From: Mick
Sent: 28 September 2018 10:57
To: Harriet Frank
Subject: Horseshoe Cottage, Cloughton NYM/2018/0400/FL

AMENDED

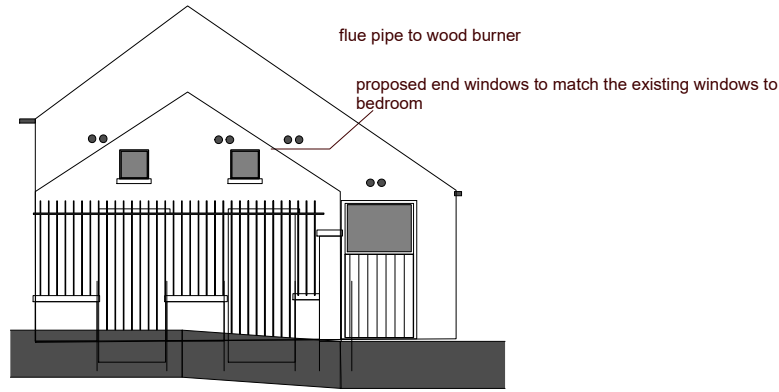
I have had another look and if we raise the eaves level up to match the existing cottage - or we could vary that slightly - and fit the new roof at the raised level - which is about 500mm higher and at the same pitch as the existing.

to accommodate this lift the new section of wall on the east elevation could be a fully glazed window infill as shown to identify this change

east elevation

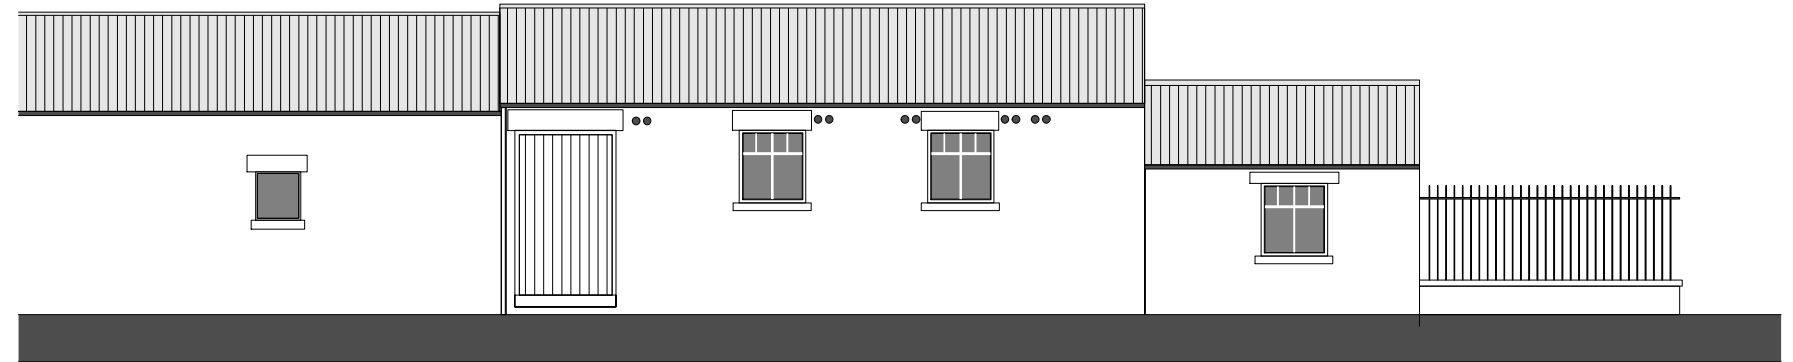
existing window to be modified and made into opening door with access to grassed area

existing window removed and new window to match existing style constructed to same width and head position but 200 mm deeper

west elevation

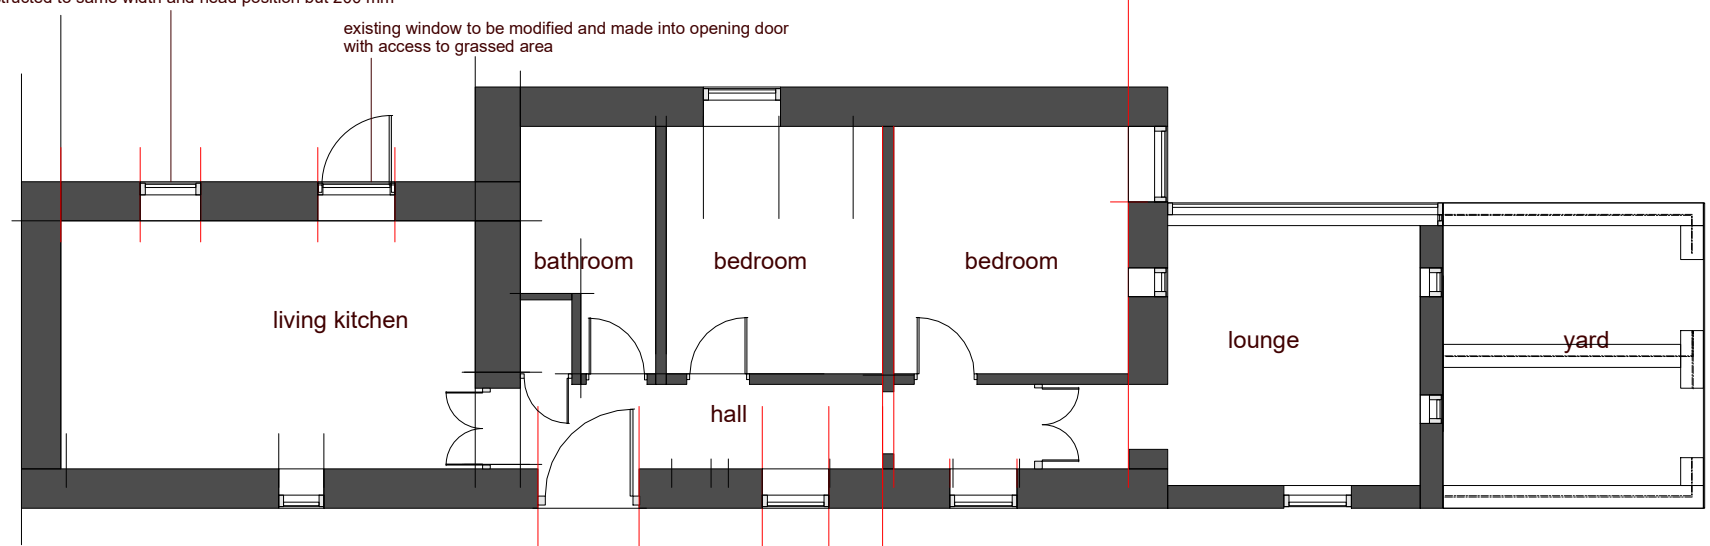
existing window removed and new window to match existing style constructed to same width and head position but 200 mm deeper

existing window to be modified and made into opening door with access to grassed area
